DOCUMENT 00 90 00
ADDENDUM

ADDENDUM NO. [2] **Date: February 24, 2021**

RE: WESTERN TECHNICAL COLLEGE
SPARTA PUBLIC SAFETY EXPANSION
11177 COUNTY HWY A
SPARTA, WISCONSIN 54656
HSR PROJECT NO. 20028

This Addendum consists of [5] pages, [1] Revised Bid Form, [1] specification section [21] 30 x 42 drawings and [1] prior product approval.

1 SECOND FLOOR LIGHTING PLAN - AREA B
SCALE: 1/8" = 1'-0"
20-07-E-LP02

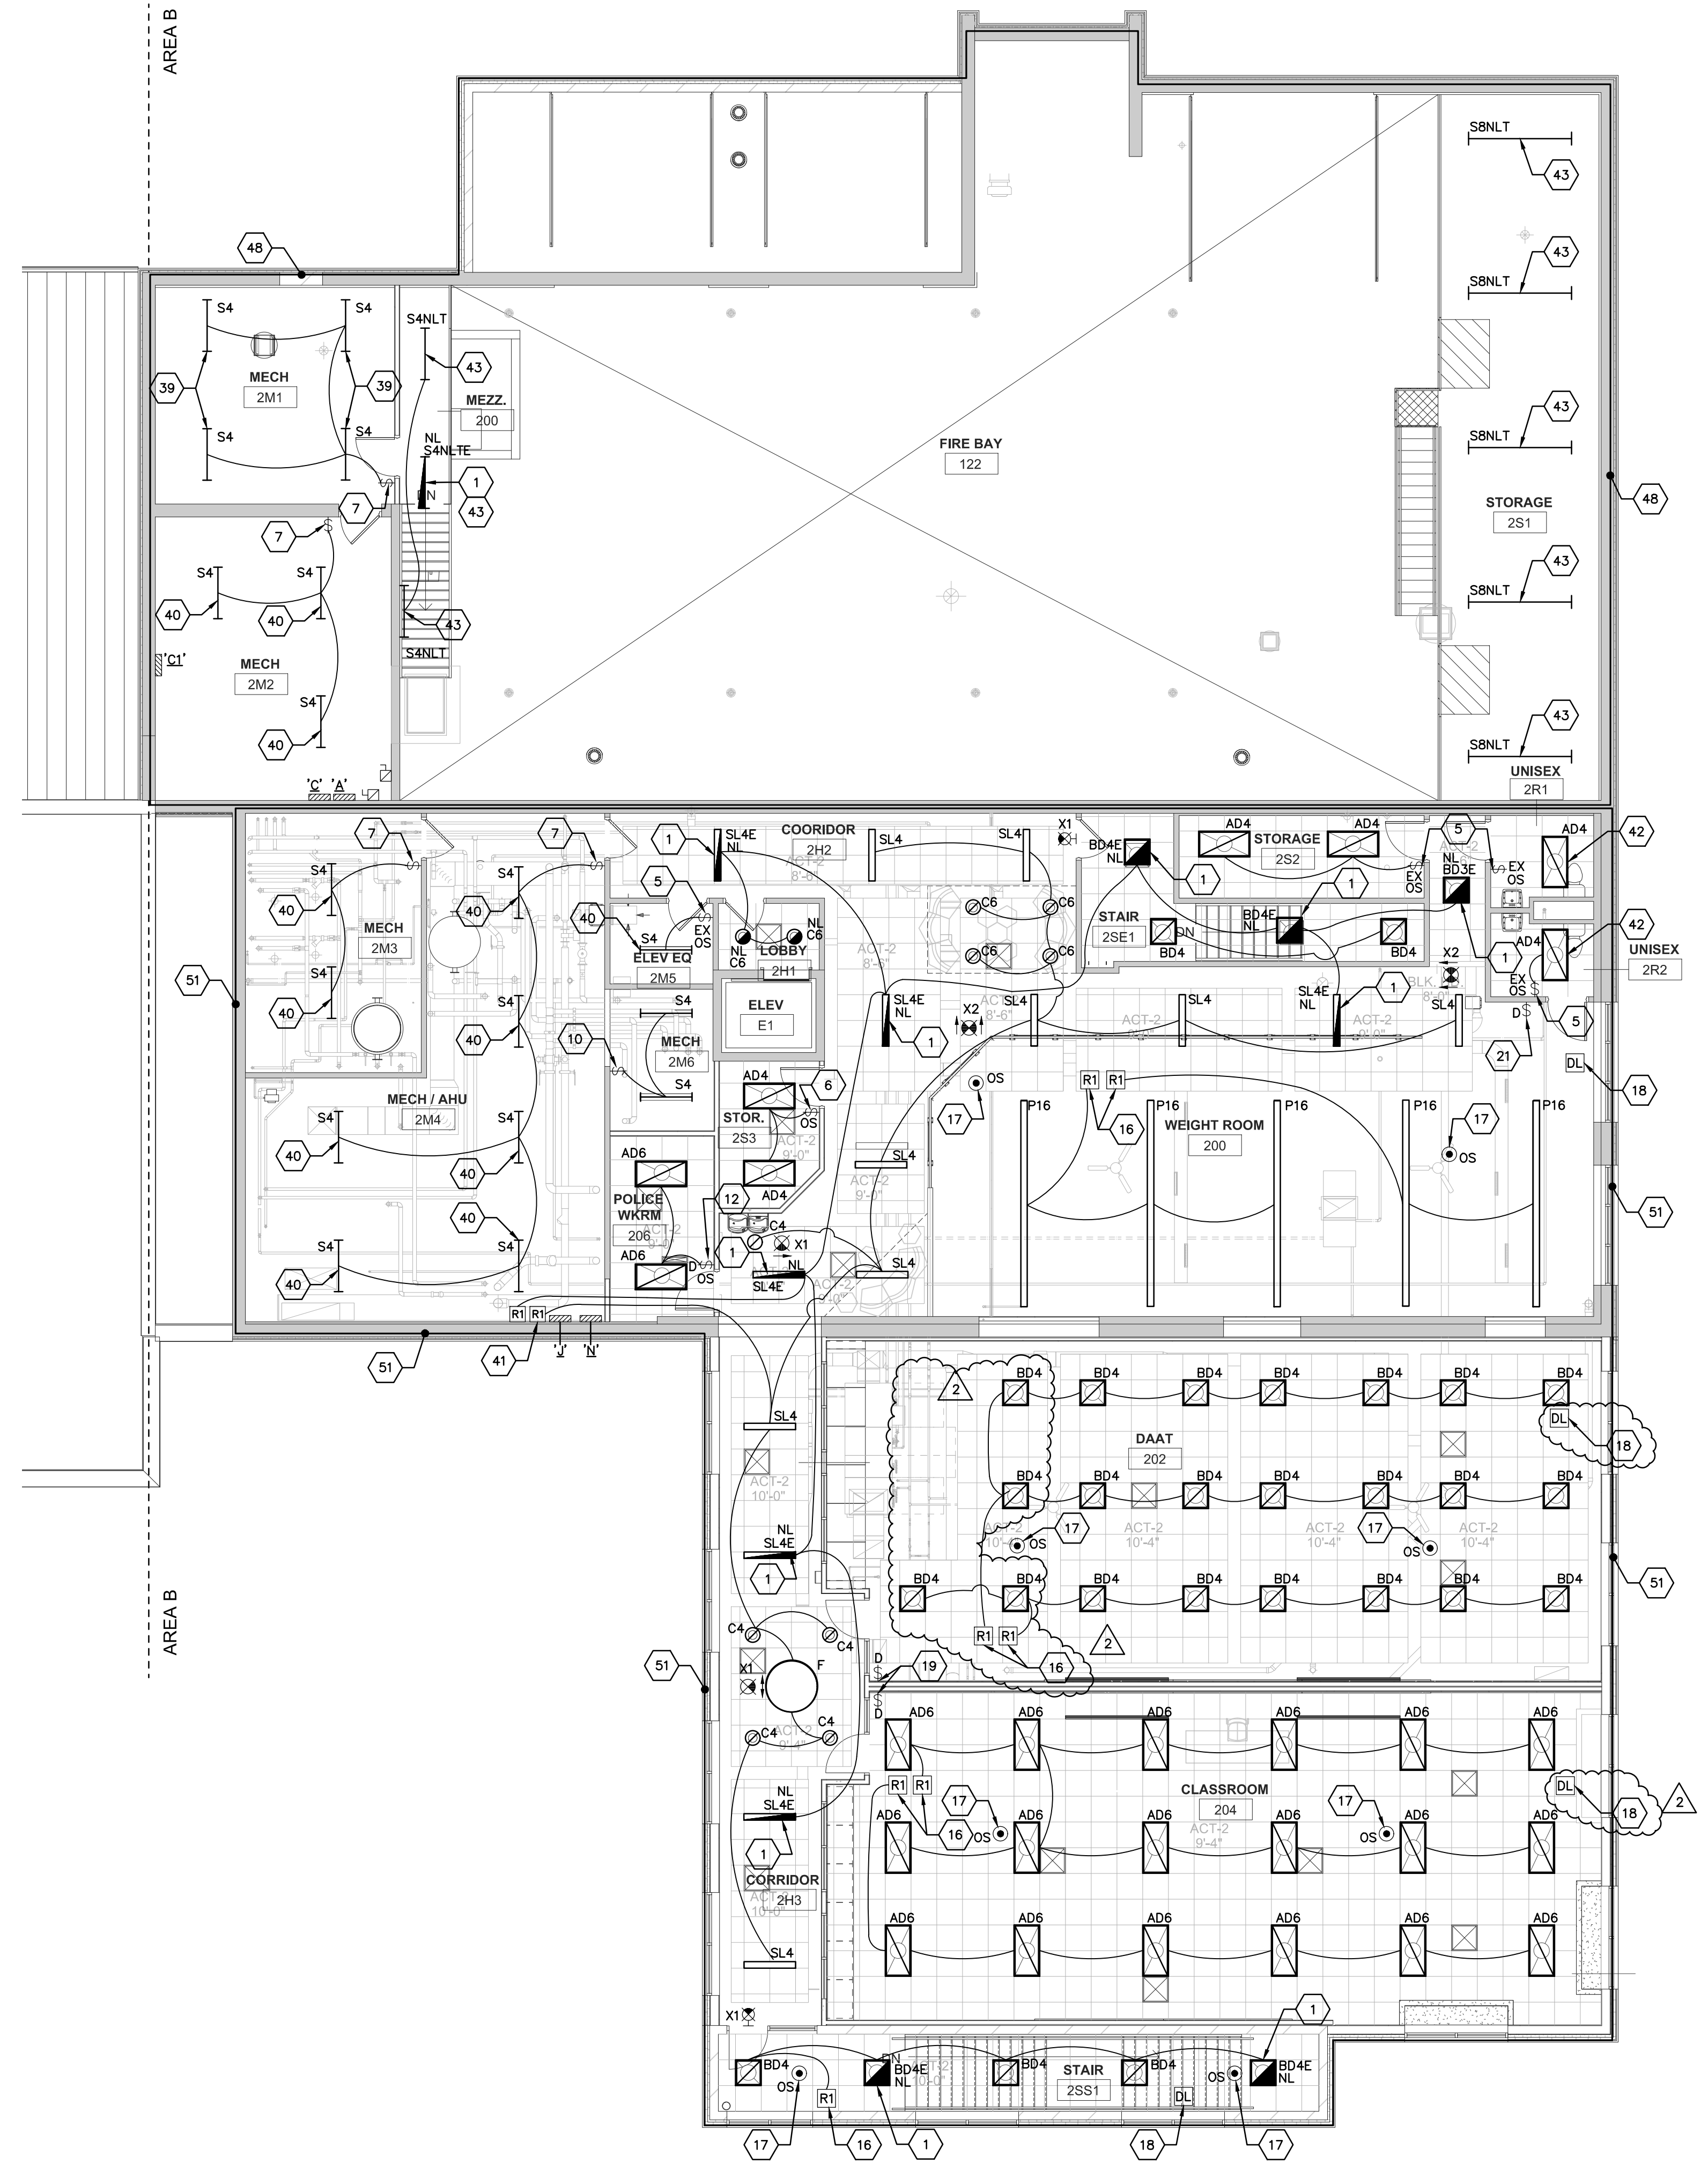
28. Sheet E103 SECOND FLOOR LIGHTING PLAN – AREA B 30 X 42 attached hereto

- a. Revisions clouded on Drawing
- b. In DAAT Room #202; Provide a Daylight Sensor. Refer to clouded change with keyed note #18 dated 2-24-2021. In addition, delete Three (3) type 'BD4' lighting fixtures located at the West side of room due to relocated AHU in this room.
- c. In Classroom #204; Provide a Daylight Sensor. Refer to clouded change with keyed note #18 dated 2-24-2021.

1 FIRST FLOOR POWER PLAN - AREA B
SCALE: 1/8" = 1'-0"
20-07-E-PP01

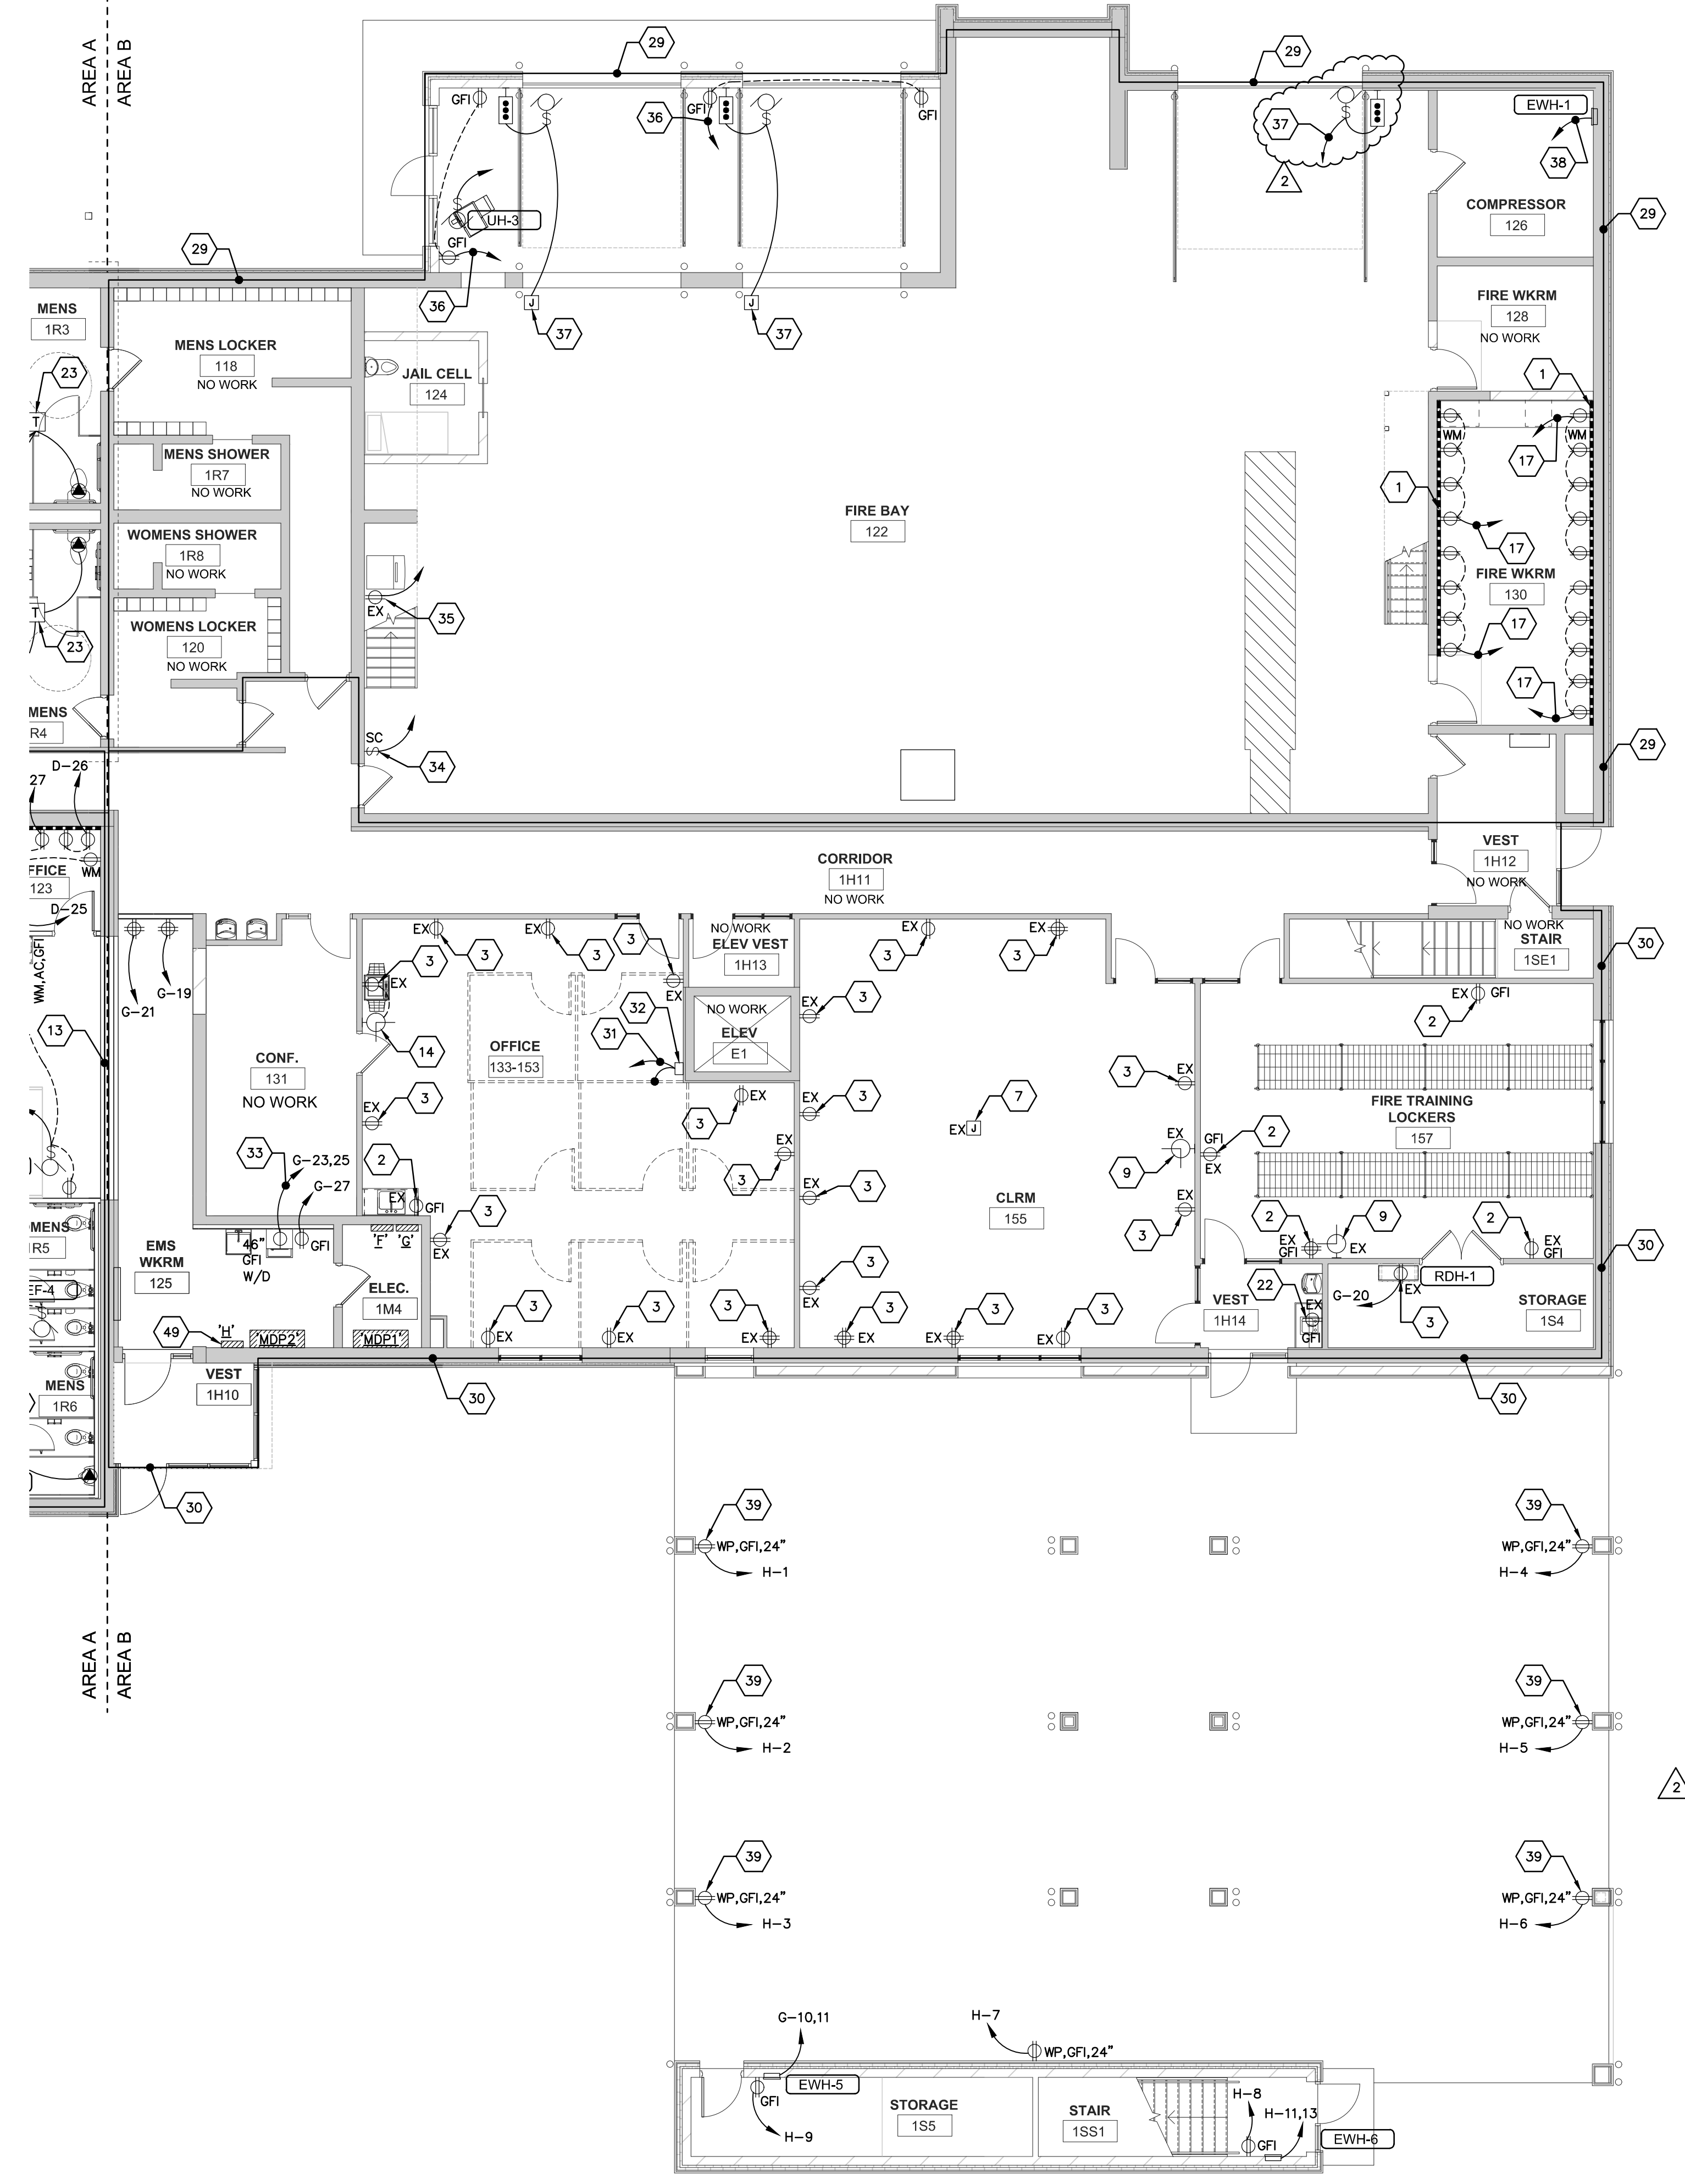
30. Sheet E202 FIRST FLOOR POWER PLAN – AREA B 30 X 42 attached hereto

- a. Revisions clouded on Drawing
- b. Refer to Fire Bay #122; Disconnect and Reconnect a motorized overhead door operator located on the East side of the room. Reuse existing branch-circuit wiring, disconnect, conduit, junction boxes, etc. to the extent possible. The intent is for a disconnect of the existing garage door and a reconnect of the new replaced garage door. Refer to clouded change with keyed note #57 dated 2-24-2021.
